Safety Notice

200004

Subject: Turntable Rotation Bearing Bolts

- 1 Bolts, PN 1256170GT
- 2 Washer, PN 1256182
- 3 Turntable rotation bearing

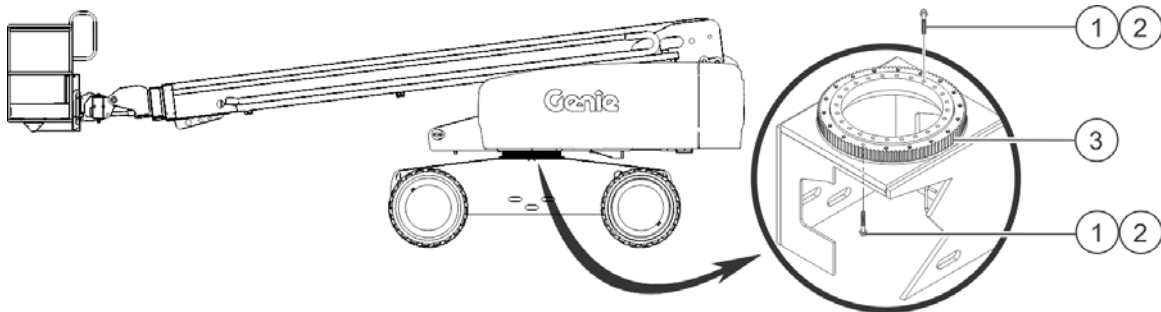
Genie has been notified of three instances where the bottom turntable rotation bearing bolts in the machines referenced above have come loose causing the separation of the turntable from the chassis. **Separation of the turntable from the chassis can result in a machine tip-over or other structural failure.**

- 1 Locate the affected machines referenced above within your fleet.
- 2 **Machines with a year of manufacture 2019 up to the release date of this notice (see Table 1):**
 - Remove the machine from service.
 - Following the instructions starting on page 3, confirm that each turntable bearing bolt is torqued to specification.

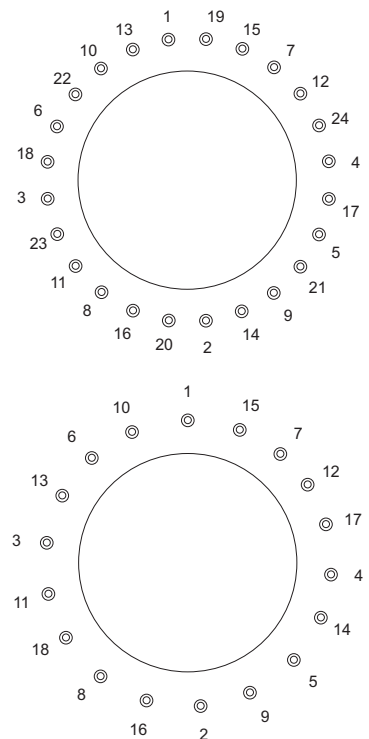
- 1 Raise the (primary) boom and place a safety chock on the lift cylinder rod. Carefully lower the boom until it is 1 inch / 2,5 cm from the lift cylinder safety chock OR support the boom assembly with a suitable lifting device.
- 2 Turn the key switch to the off position.
- 3 Using a star pattern, confirm that each upper turntable rotation bearing bolt (24 X) is torqued in sequence to the specification.

- 4 Raise the boom and remove the safety chock OR lifting device.
- 5 Lower the boom to the stowed position.
- 6 Using a star pattern, confirm that each lower turntable rotation bearing bolt (18 X) is torqued in sequence to the specification.
- 7 **Torque Specification = 180 ft-lbs / 244 Nm**

Torque Specification = 180 ft-lbs / 244 Nm
